Item Name: 206A/B/L-Series Cable Cutter System, High

APICAL INDUSTRIES, INC.	ENGINEERING CHANGE NOTICE NO. 03047				SHEET 1 OF 1	
	DWG NO. 646.9500	REV: NC	PREPARED BY J. JACKSON	DATE: 01/24/11	EFFECT ON DWG ☐ INC. ☒ UNINC.	
	DWG TITLE: 206 CABLE CUTTERS KIT					
APPROVED BY: ENGR <i>[Signature]</i>		MFG <i>[Signature]</i>	QC <i>[Signature]</i>	EFF: NEXT ORDER		
TRANSACTION CODES (TC): A-ADD C-CREATE R-REVISE D-DELETE		REASON: ADDED GPS MOUNT KIT, F/N 52. REVISED DRAWING VIEWS. ADDED NOTE <u>2</u>

APICAL INDUSTRIES, INC.	ENGINEERING CHANGE NOTICE NO. 02736				SHEET 1 OF 1	
	DWG NO. 646.9500	REV: N/C	PREPARED BY S. HUFF	DATE: 01/06/10	EFFECT ON DWG ☐ INC. ☒ UNINC.	
	DWG TITLE: 206 CABLE CUTTERS KIT					
	APPROVED BY:	ENGR <i>[Signature]</i>	MFG <i>[Signature]</i>	QC <i>[Signature]</i>	EFF: CURRENT ORDER	
TRANSACTION CODES (TC): A-ADD C-CREATE R-REVISE D-DELETE	REASON: CORRECTED PARTS LIST ERRORS

APICAL INDUSTRIES, INC.	ENGINEERING CHANGE NOTICE NO. 02729				SHEET 1 OF 3	
	DWG NO. 646.9500	REV: N/C	PREPARED BY S. HUFF	DATE: 12/23/09	EFFECT ON DWG ☐ INC. ☒ UNINC.	
	DWG TITLE: 206 CABLE CUTTERS KIT					
APPROVED BY: ENGR <i>[Signature]</i>		MEG <i>[Signature]</i>	QC <i>[Signature]</

SHEET 1, ZONE B1 IS:

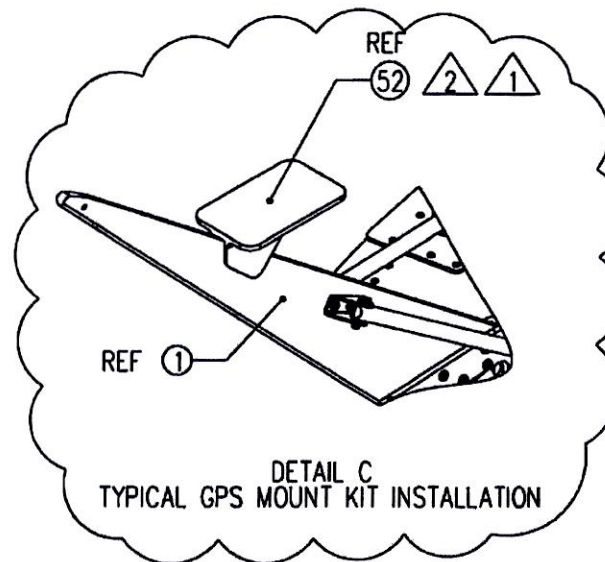
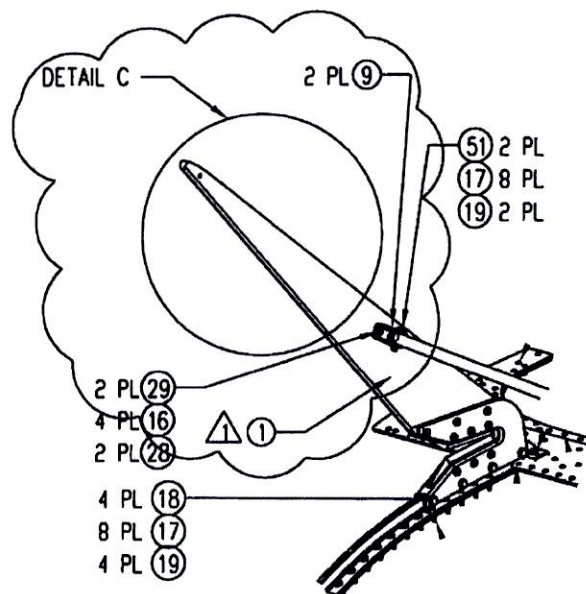
2 AT CUSTOMERS OPTION, INSTALL F/N 52 BY MATCH DRILLING ONTO F/N 1.

52	A	647.5701	REF	REF	GPS MOUNT KIT	<u>2</u>	
F/N	TC	PART NUMBER	.9502	.9501	DESCRIPTION	MATERIAL	SPECIFICATION
			QTY				
DOCUMENTS EFFECTED:						CHANGE CATEGORY	DER REVIEW REQUIRED
☐ MDL ☐ INSTALL INSTRU ☐ ICA ☒ BOM						☐ MAJOR ☒ MINOR	☐ YES ☒ NO

SHEET 2, VIEW IS:

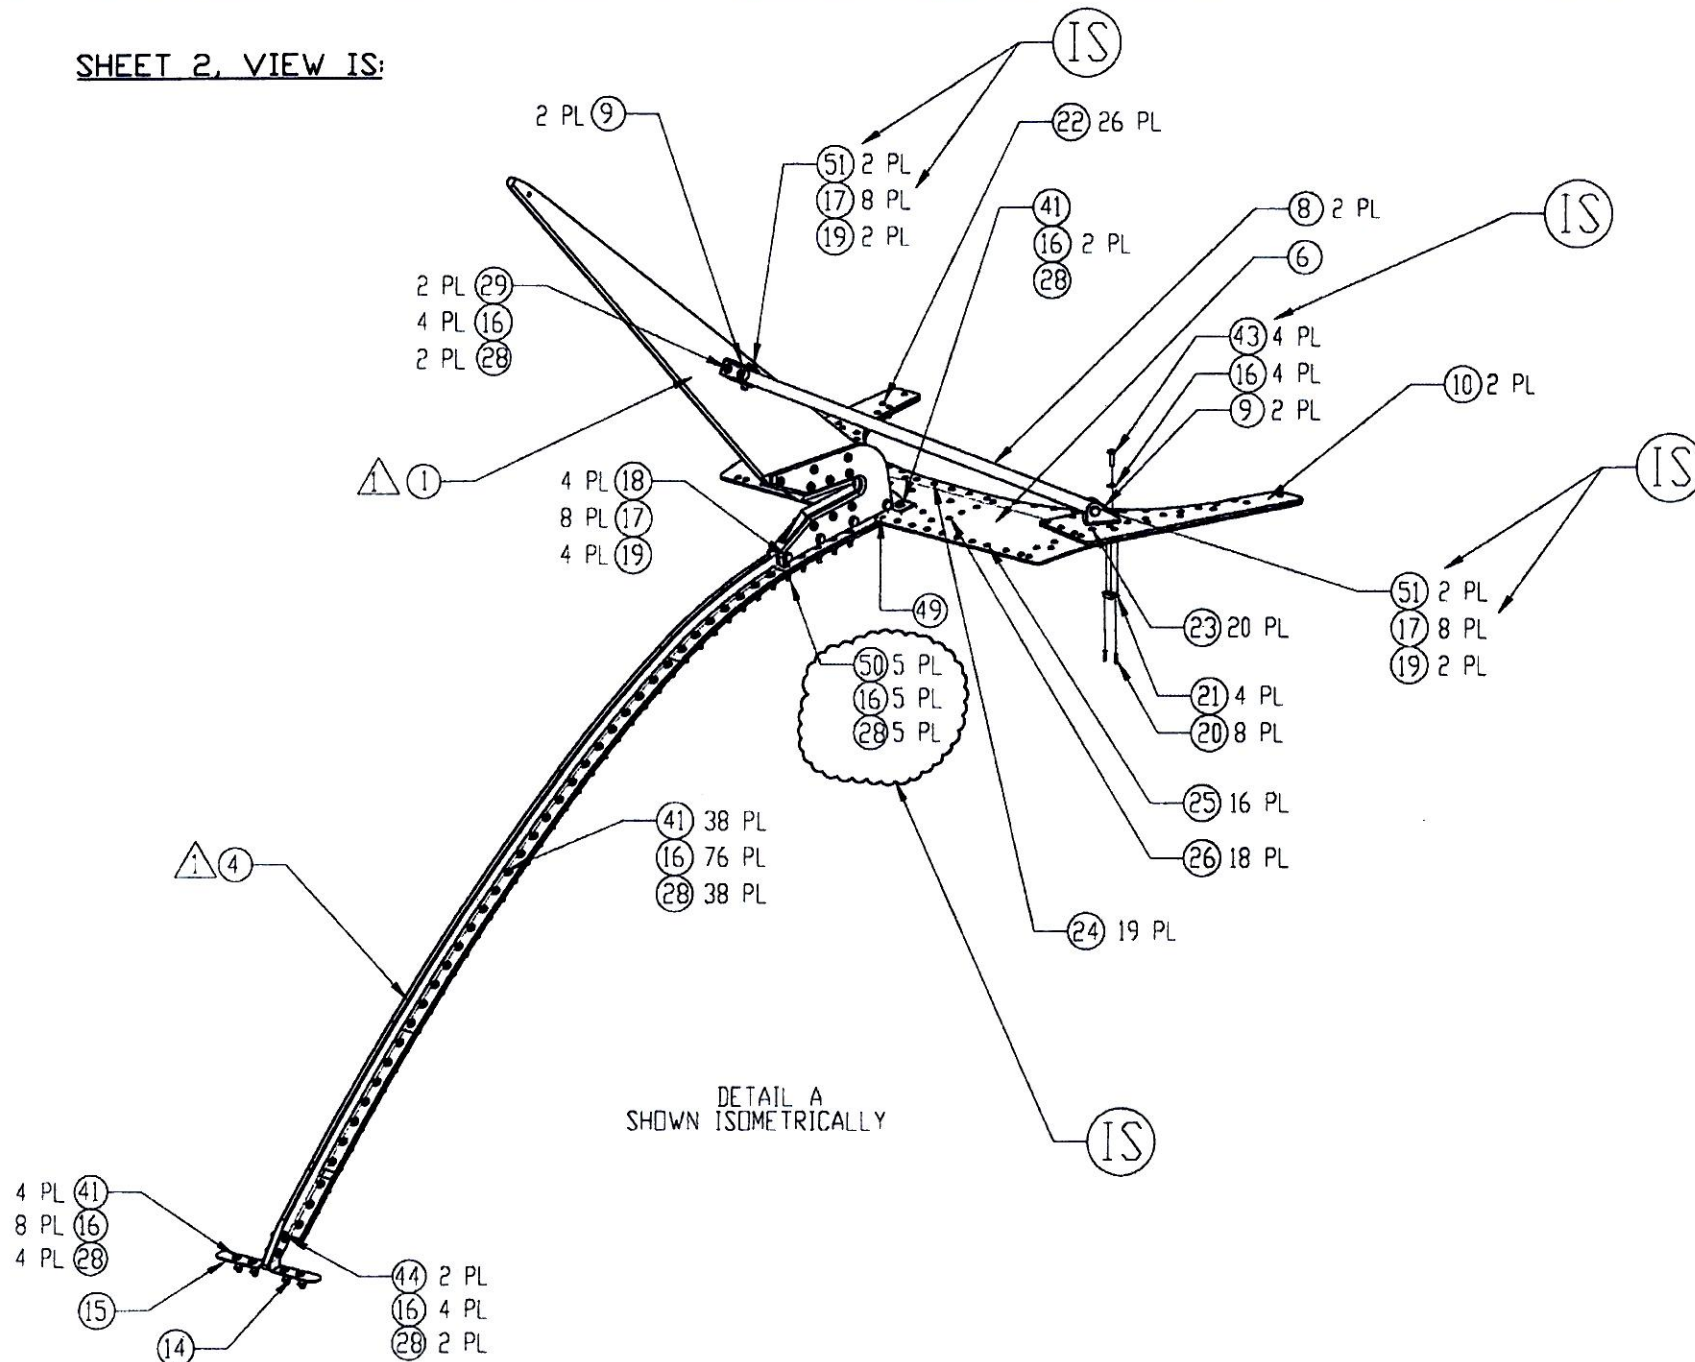
51	A	601.3155	8	8	BOLT	AN3-10A
50	A	601.3153	5	5	SCREW	MS24694S8
41	R	601.2893	43	43	SCREW	MS27039-0811
28	R	601.2973	54	54	LOCKNUT	MS21042-08
18	R	601.2826	8	8	BOLT	AN3-11A
16	R	601.2764	127	127	WASHER	NAS1149FN832P
			9502	9501		
F/N	TC	PART NUMBER	QTY		DESCRIPTION	MATERIAL/SPECIFICATION
DOCUMENTS EFFECTED: ☐ MDL ☒ INSTALL INSTRUC ☒ ICA ☐ FMS ☒ BOM						CHANGE CATEGORY ☐ MAJOR ☒ MINOR
						DER REVIEW REQUIRED ☐ YES ☒ NO
